ADDENDUM NO. 1

DATE: March 27, 2020

FROM: Baxter & Woodman, Inc., Consulting Engineers

VILLAGE OF HOFFMAN ESTATES, ILLINOIS  
CHIPPENDALE LIFT STATION REHABILITATION

**ELECTRICAL SITE PLAN**

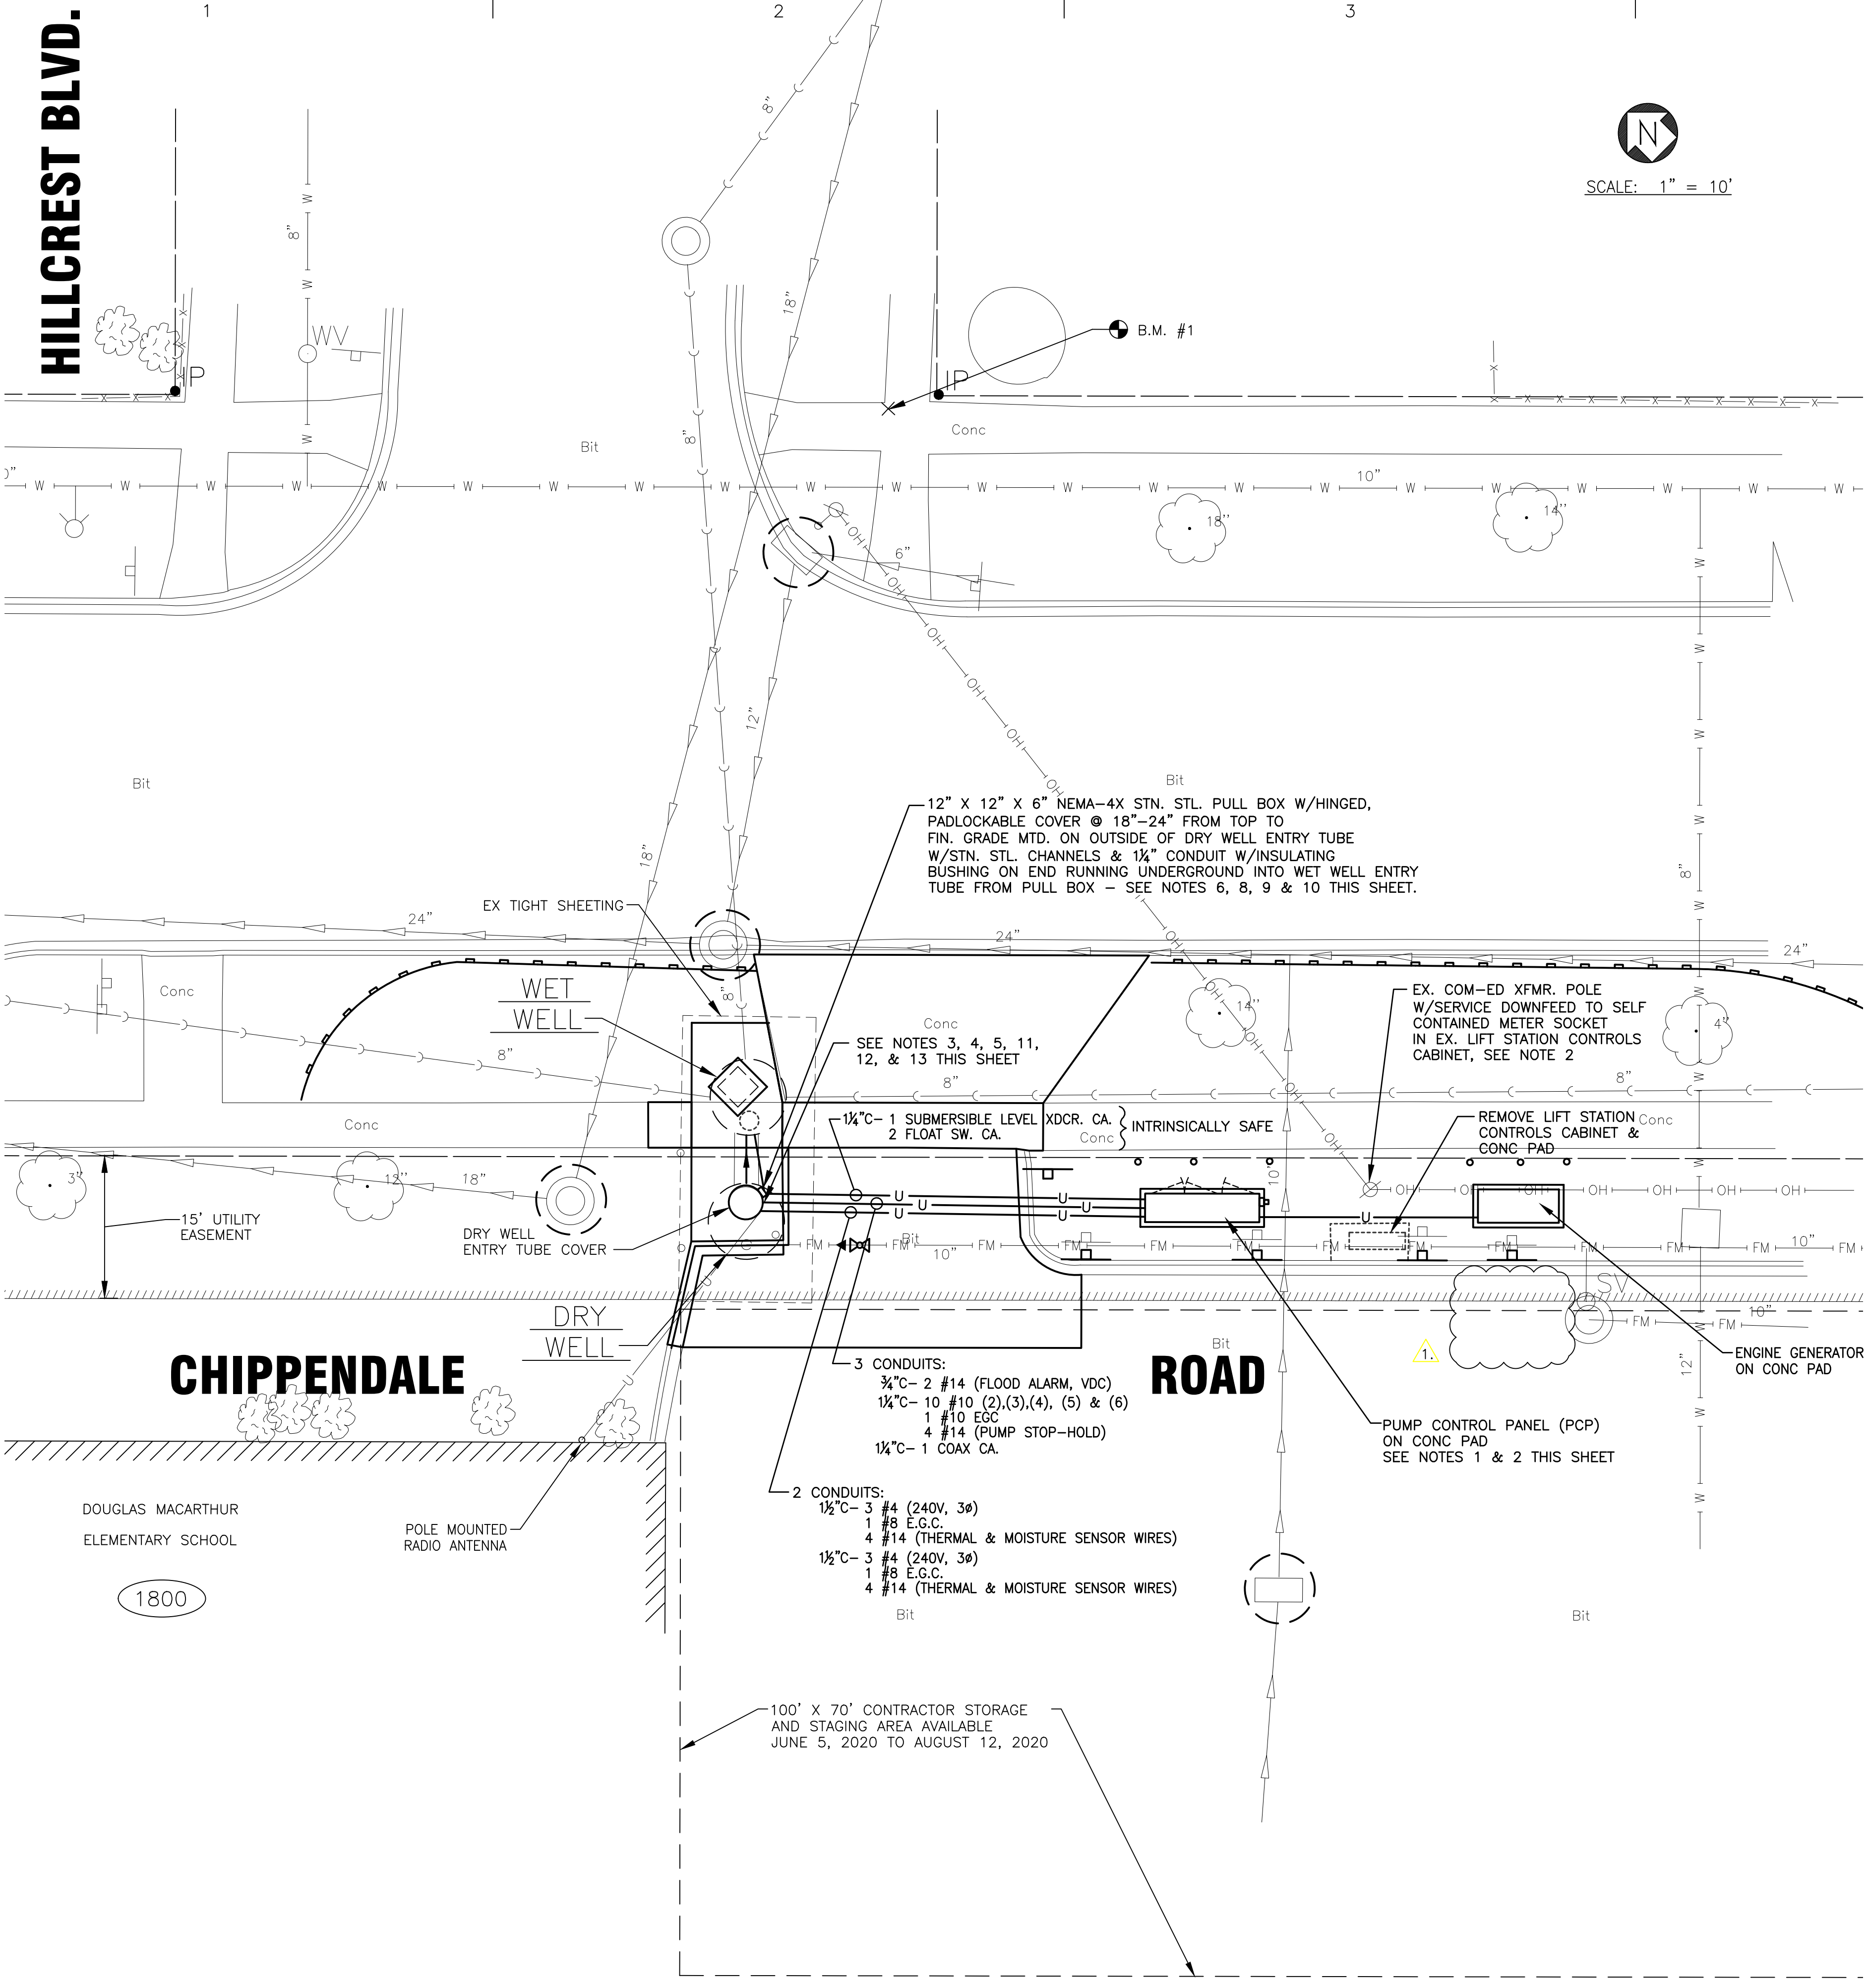
- D. Delete Sheet E-2 in its entirety, and insert attached Sheet E-2, revision dated March 26, 2020 in lieu thereof.

Revision to remove valve, sleeve, and required restoration southwest of engine generator.

Exhibit 1 - Sanitary Sewer Atlas

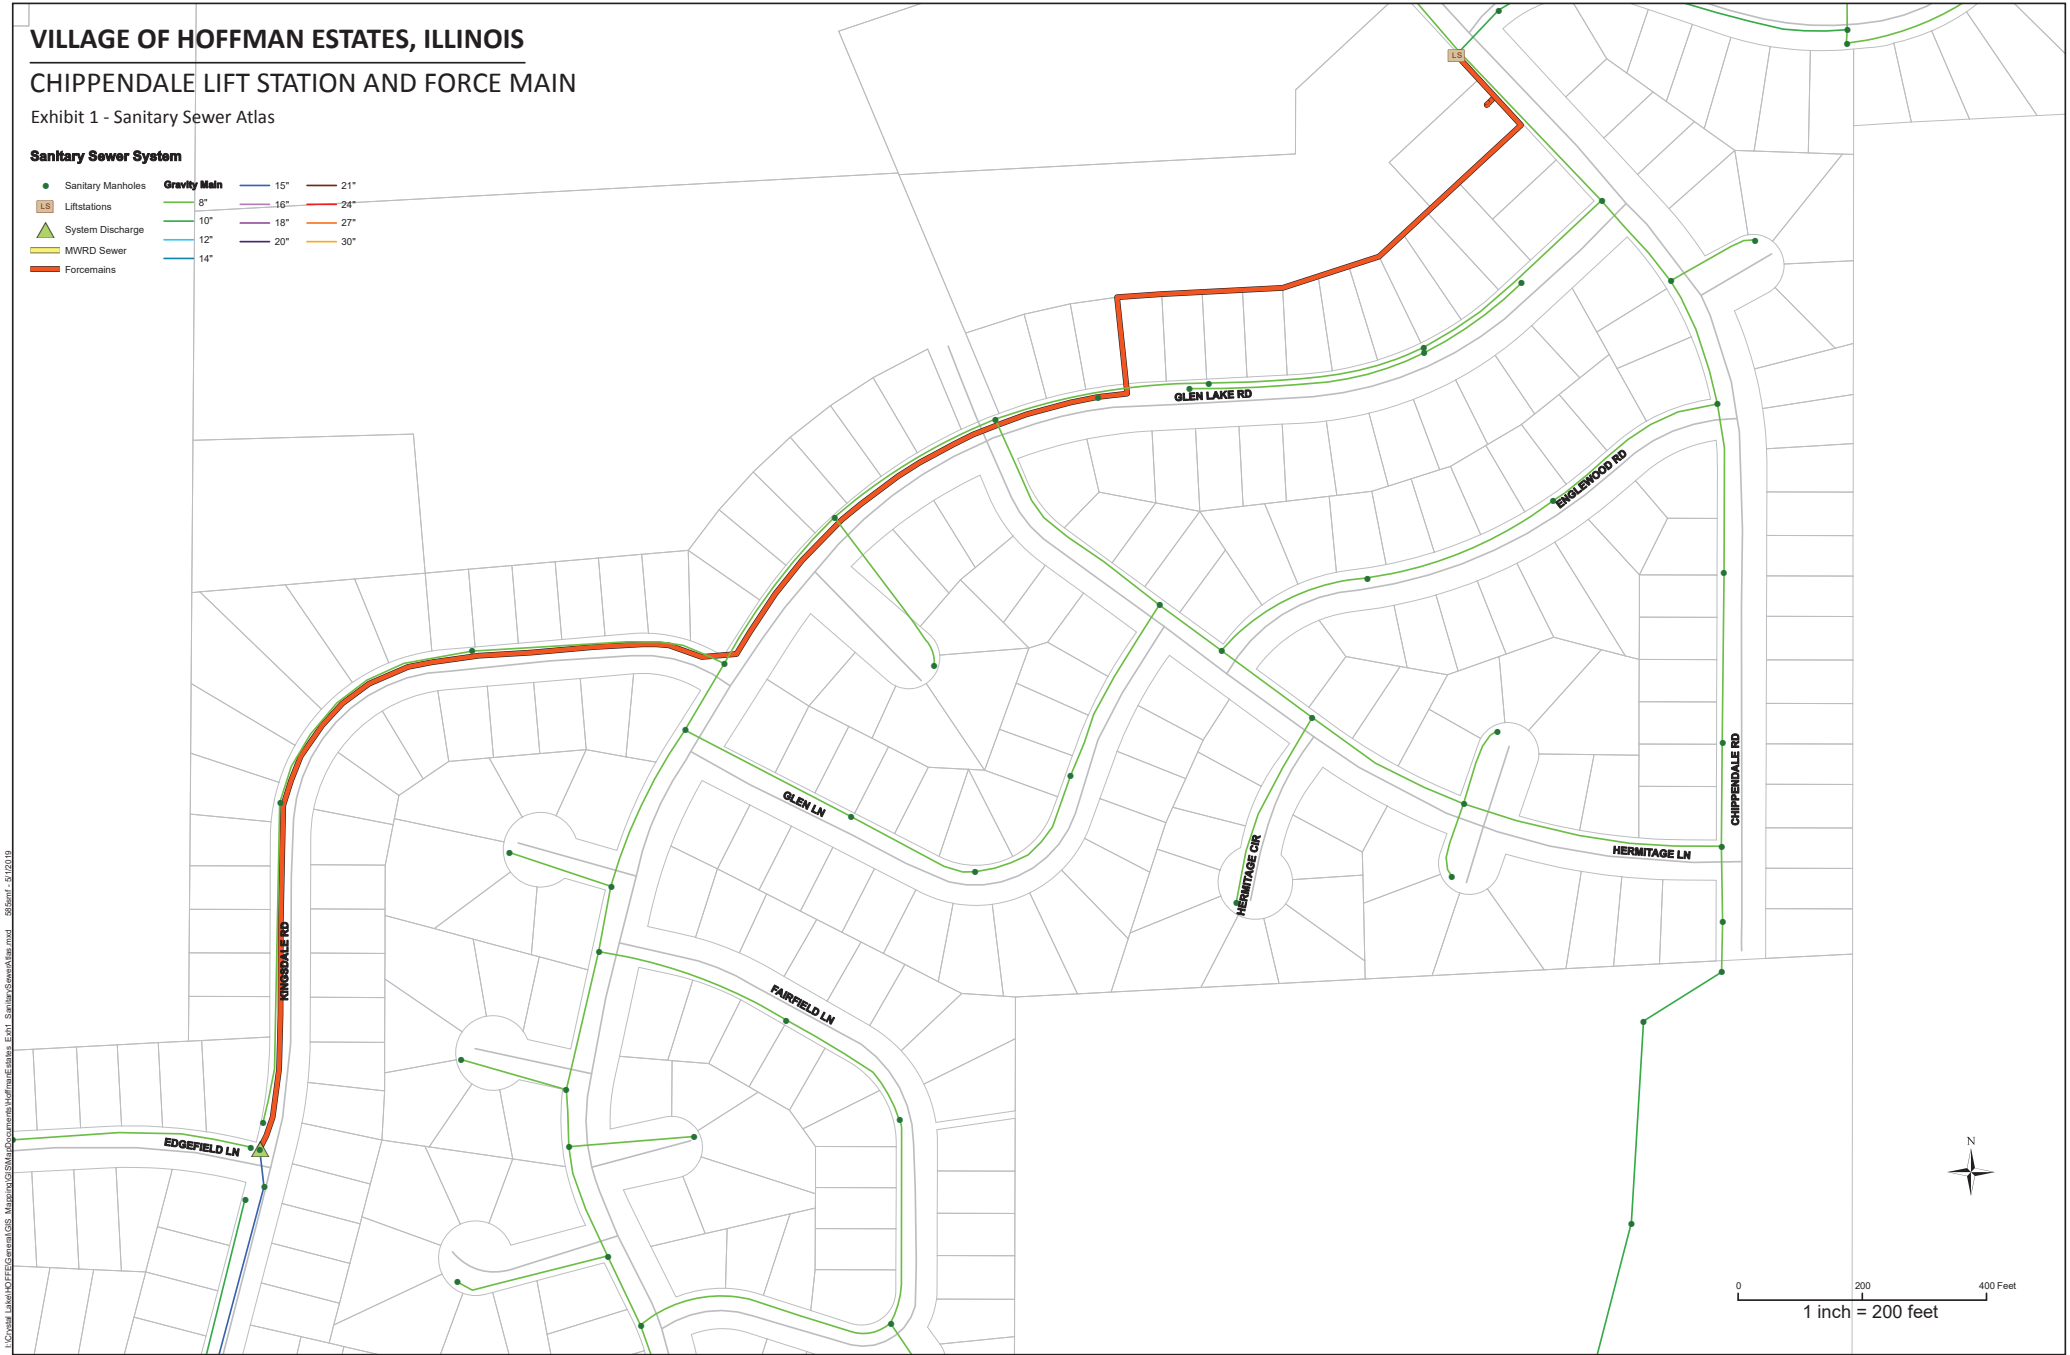
- b. *Wet Well Rehabilitation*
    - (1) *Option 1 - See attached exhibit. The wet well will have to be muni balled off utilizing three plugs stopping any flow of water into the wet well during rehabilitation work. Provide a pump at each of the upstream manholes to discharge to a central storage container or frac-out tank. Provide a central pump to convey the wastewater in the temporary storage container to the existing bypass connection and force main. The pumps at each of the manholes will require four ramps for driveways. One roadway crossing is needed which can be achieved with ramps or trenching.*
